Minutes of Meeting

Date:	20/05/03		
Doc.-No.:	HP-2-ASED-MN-390		
Meeting place:	Telecon: ESA, RAL, ASP, ASED	Chairman:	
Date/Time:	20.05.03/14h00	Secretary	H. Faas
Agenda dated:	HP-ASED-EM-023-03, 16/05/03	Close of Meeting:	20/05/03, 16h15

Subject: Telecon: SPIRE harness and shielding

**SPIRE Cryo-SIH to Warm-units
 D*MA connector +RFI Backshell**

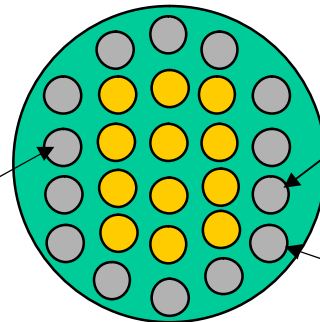
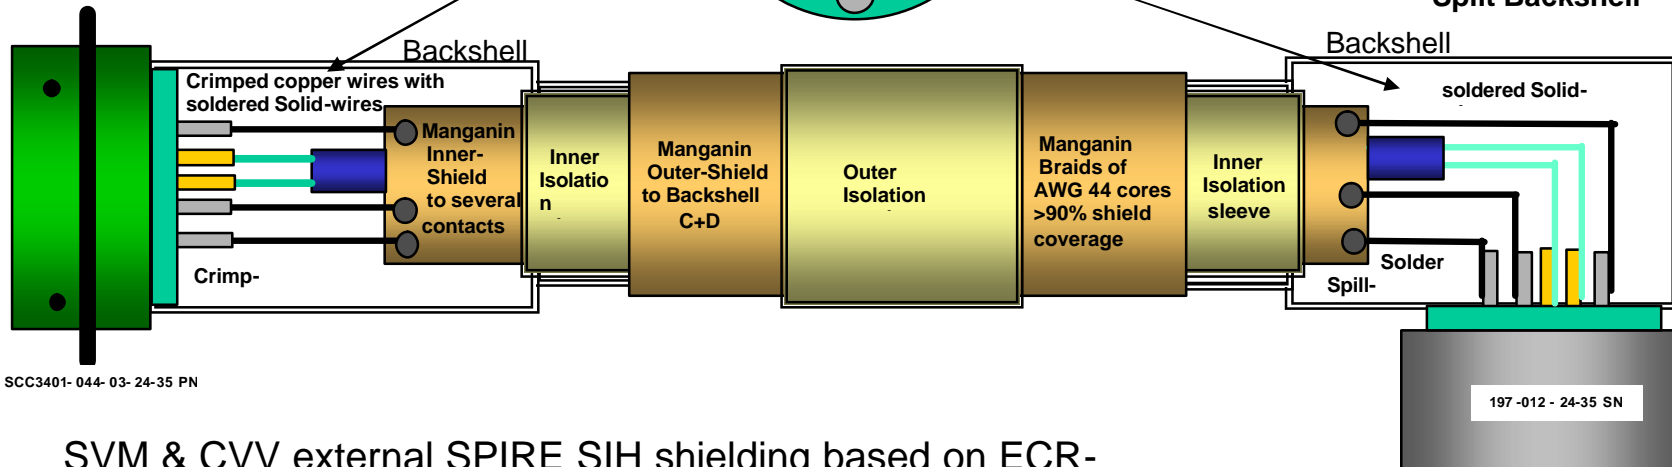
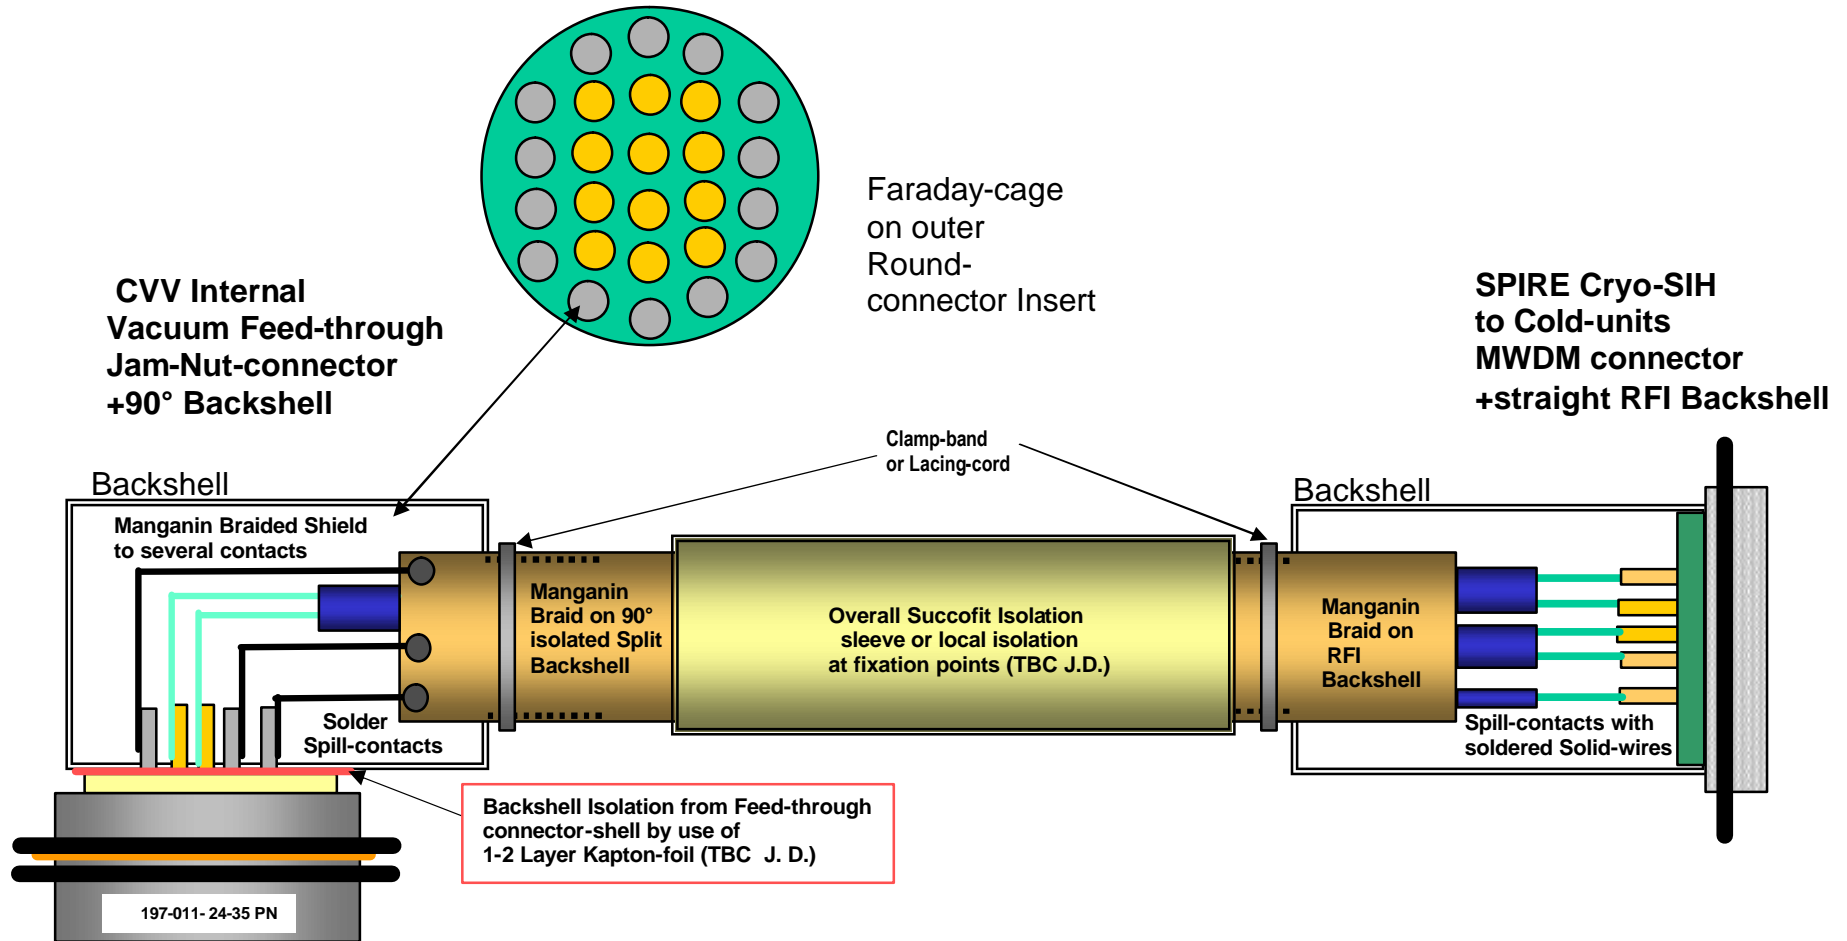
Reference	Results	Remarks
	<p>Assuming that the SPIRE ECR-039 is only partially rejected (i.e. only internal overall shielding), ASED outlined an engineering solution (see also attached ASED viewgraphs, prepared as part of the ECR-039 analysis):</p> <ul style="list-style-type: none"> - The SVM harness (i.e. harness between warm units and Connector Bracket, CB) would have an double Al overall shielding with an Goretex layer to ensure insulation between the two shields - The intermediate harness between the CB to CVV external wall would consist of two Manganin braids with an Goretex insulation in between. The outer overshields would be connected to the CVV external backshells of feed-through connectors. The inner overall shield would be interconnected to the outer ring pins of the feed-through connector by daisy chaining. - Internal in the CVV two wires would ensure the connection from those outer ring pins to the FPU ground. Several options need to be studied. It seems that two single wires in form of twisted cables could be most feasible solution. - The implementation of the splicing (position and method) need to be analysed, e.g. taking RAL/SPIRE proposal, see SPIRE HDD, Page 114 into account. <p>ASED stated that an impact assessment with the input from CASA and ASSE would be available: 30 June 2003.</p> <p>ASED stated that the partial implementation of SPIRE ECR-039 could not be reflected in the Cryo Harness PDR baseline, as the PDR will take place on 26-27 Mai at CASA. The SPIRE Harness baseline will be according to the ASP instruction (see Ref. 2 and Ref. 4).</p> <p>The following implementation philosophy and action plan was agreed:</p> <p>0. RAL will issue a note exploring non-overshield internal harness implementation, and the grounding of internal backshell, see annex</p> <ol style="list-style-type: none"> 1. ASP will instruct ASED to perform an evaluation of effort and schedule impact assuming an partial implementation of the SPIRE ECR-039 2. ASED will review the cryo harness schedule and will inform ASP and ESA concerning critical dates of the harness manufacturing process for the EQM and FM harness to allow an implementation of the ECR-039 3. Following this instruction, ASED with the support of CASA and ASSE, will perform an analysis and present results (4 weeks later). Target date: 30 June 2003 4. ASED will update the Cryoharness ICD accordingly and will present an updated ECP (based on the ECP HP-2-ASED-CP-0054) 5. Based on this updated ECP, ASP and ESA will instruct ASED of the baseline for the SPIRE harness 	<p>AI#1: ASP to instruct ASED to start evaluation of the impact (effort and schedule) for an partial ECR-039 implementation.</p> <p>AI#2: ASED will present an updated ECP (partial implementation of ECR-039) following the request from ASP.</p>

Drawings to illustrate options for SPIRE cryo-harness inside CVV only..

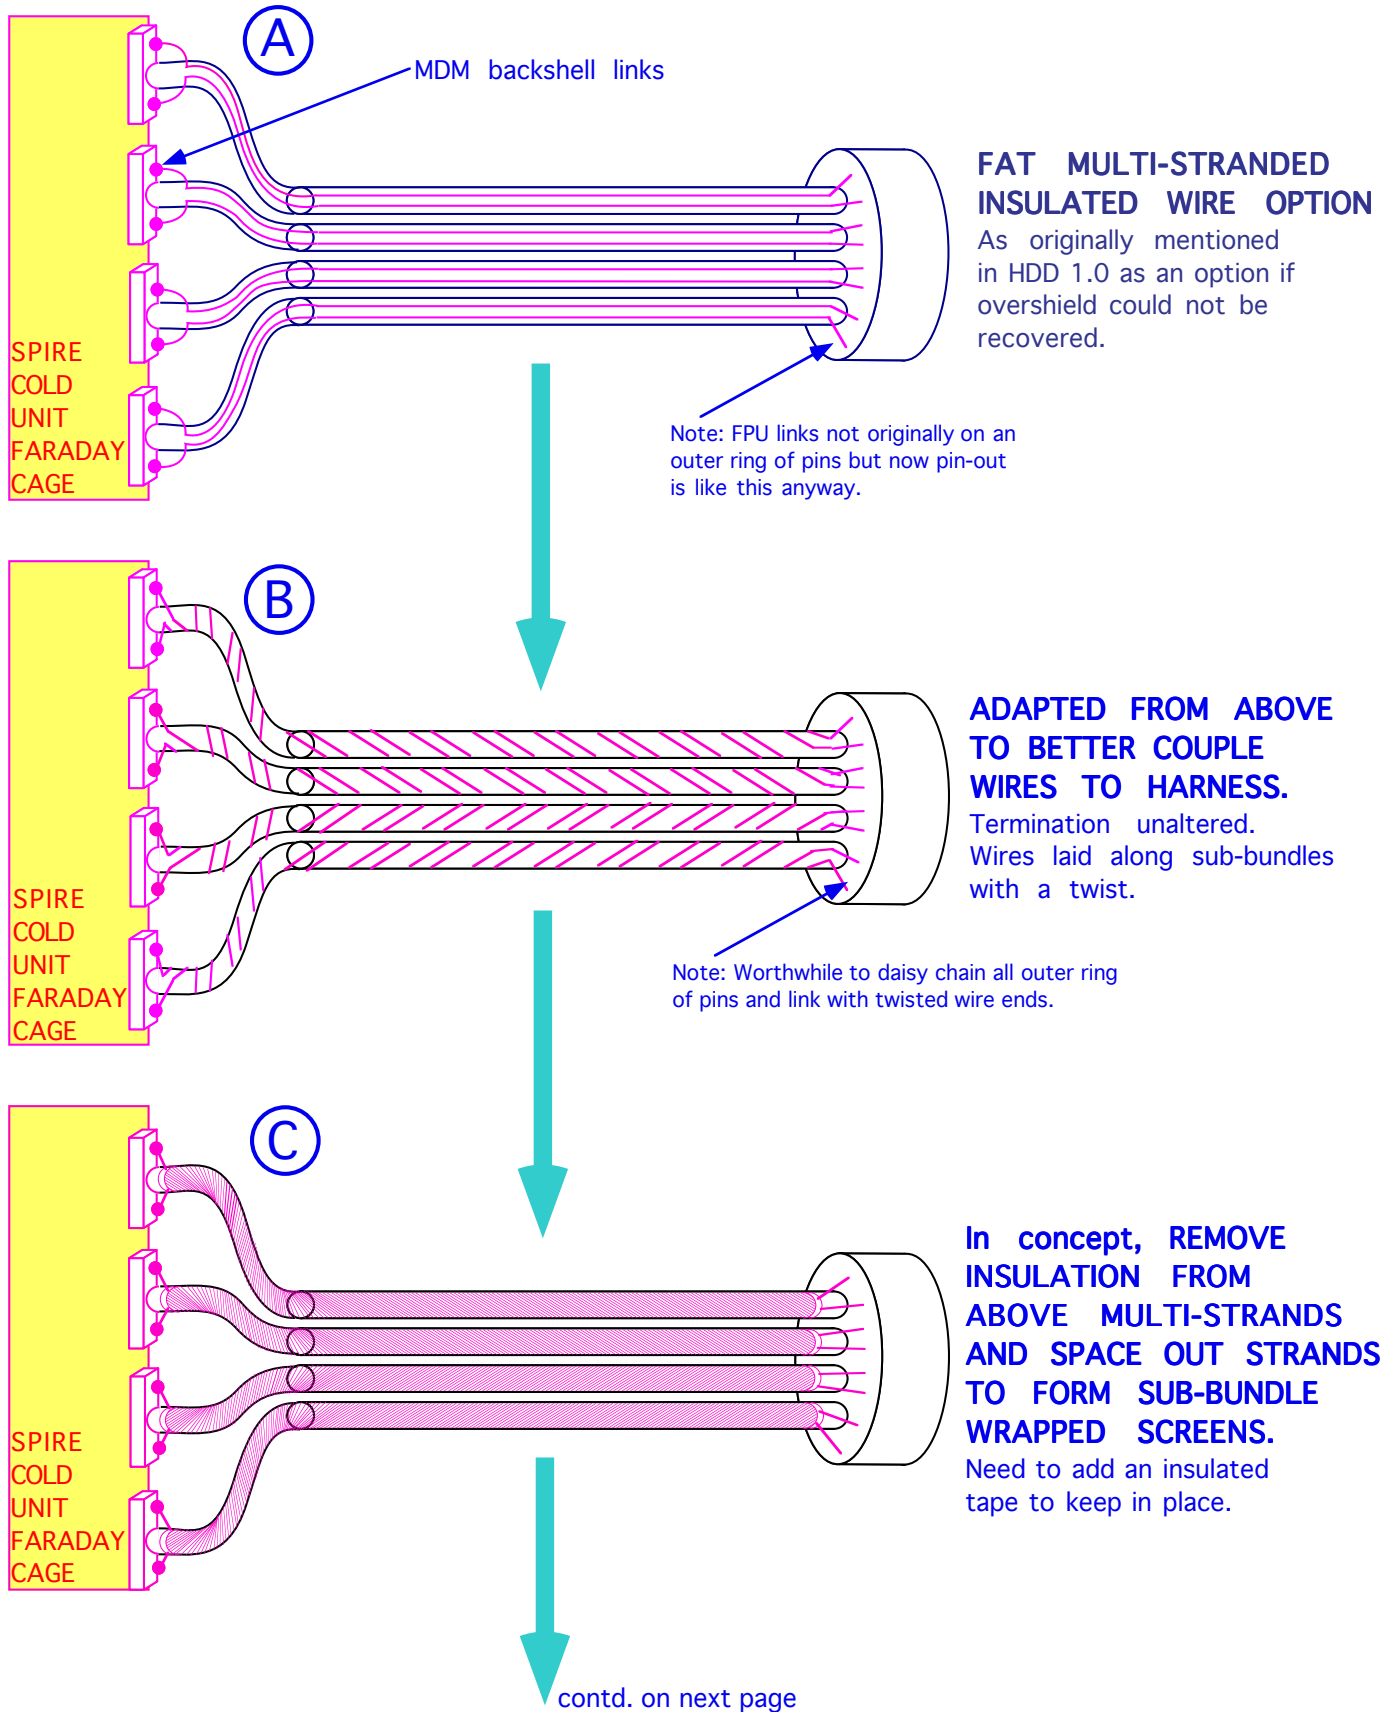
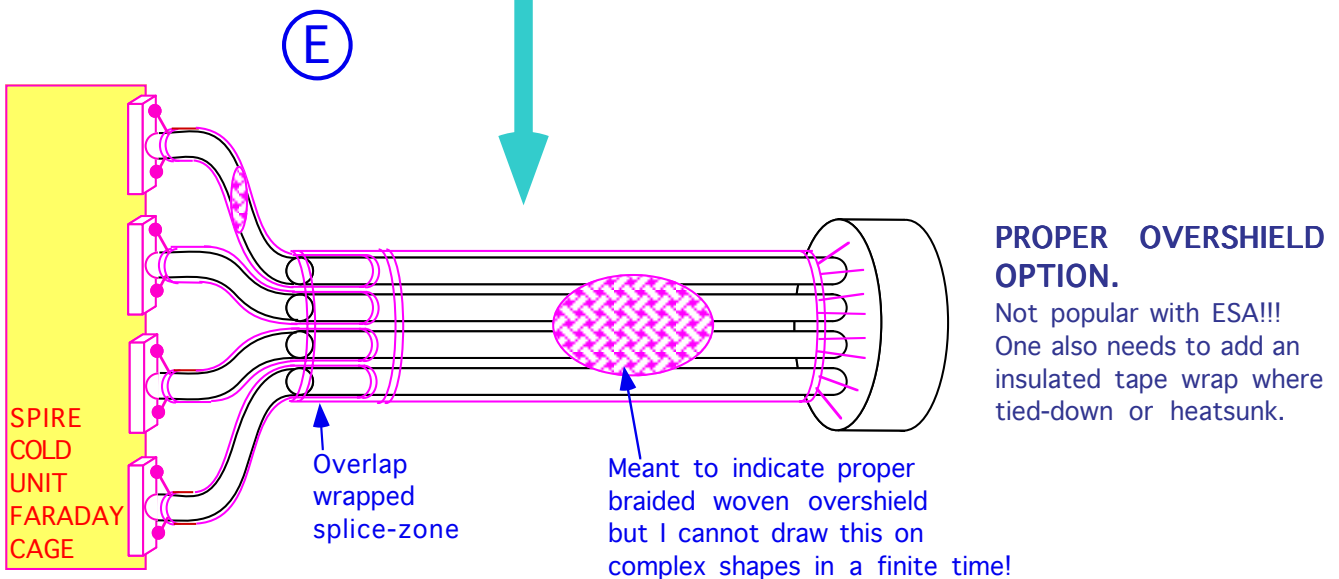
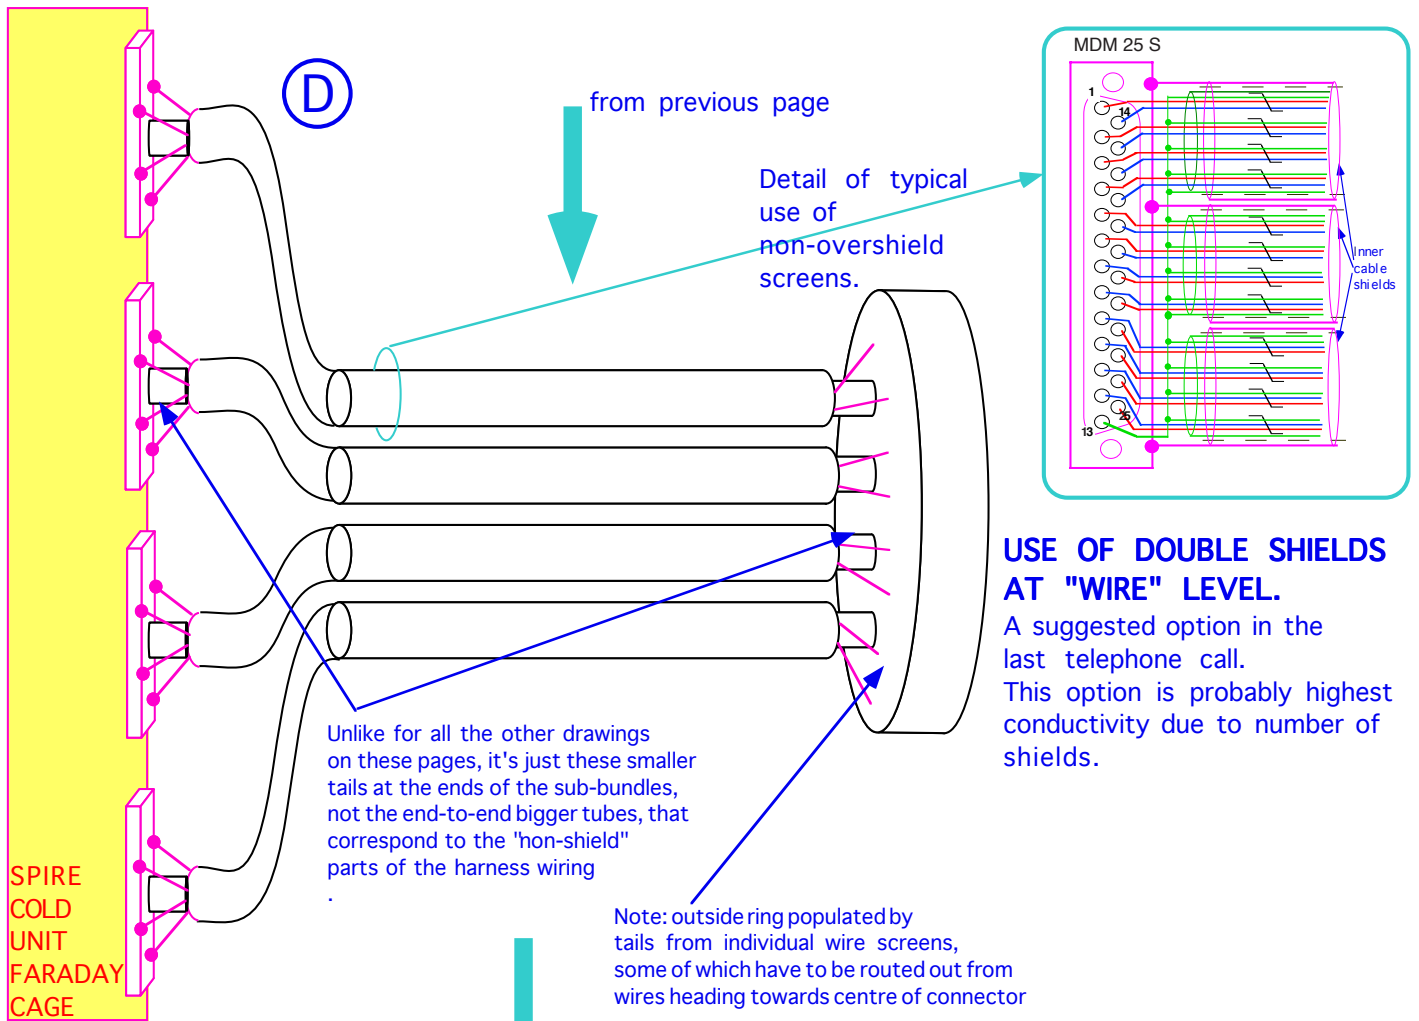
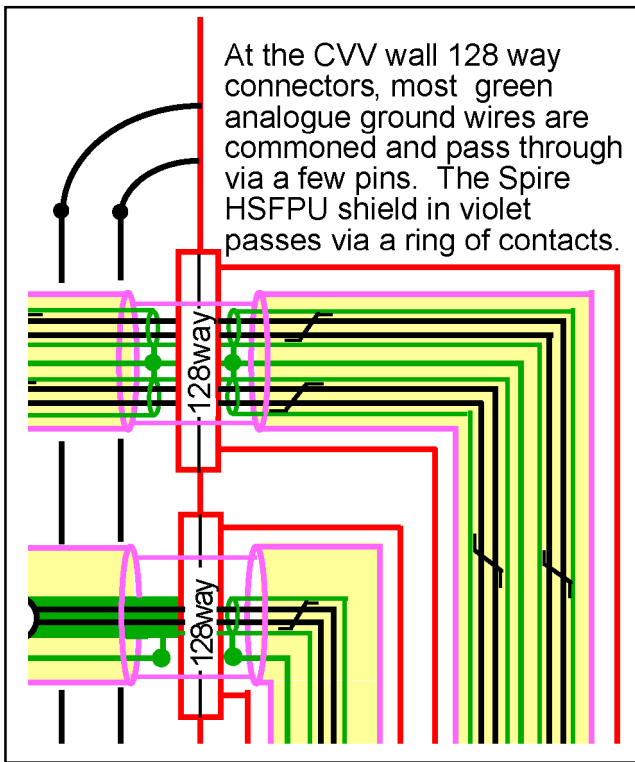
The items in black are the parts of a typical harness except the Faraday shield linkage. The items in mauve are how the FPU Faraday shield is connected to the outer ring of pins on the CVV connectors, the point under discussion. Spire designed in an overshield (option E) to keep the Faraday cage closed from day 1. ESA refused this, which is under appeal. The following explores options. Spire would accept C or D instead of E as fulfilling its functional requirements, thereby avoiding an overshield.

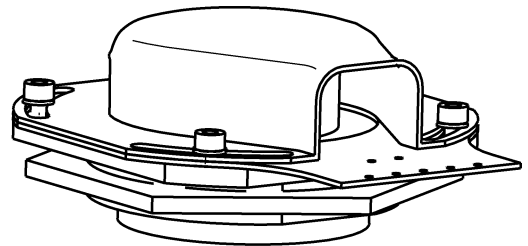
With the connectors, they look like the item shown on the right, although what the point is of making the cap rotatable w.r.t. the fastener bolts to set the harness off at an angle but not the plate escapes me!

The HSFPU shield opens out on to pins at the CVV anyway. The backshell plate and cover have 2 grounding options:

- If the backshell is connected electrically to the 128way it acts as an extension to the red CVV/connector wall as shown in the top left diagram. In this case the mauve HSFPU shield is clearly insulated from it.
- Alternatively, if the backshell has Kapton sheet spacer between it and the connector flange with sleeved Vespel washers under the boltheads, (and it's not obvious to me that the backshell itself has to change because of this alone except for bolt clearance size), it becomes isolated from the red CVV and can form part of the mauve HSFPU shield. In this case the HSFPU shield clearly is made off to it, possibly by tying the bound-up ends of shields to the main securing plate rather than with formal tails.
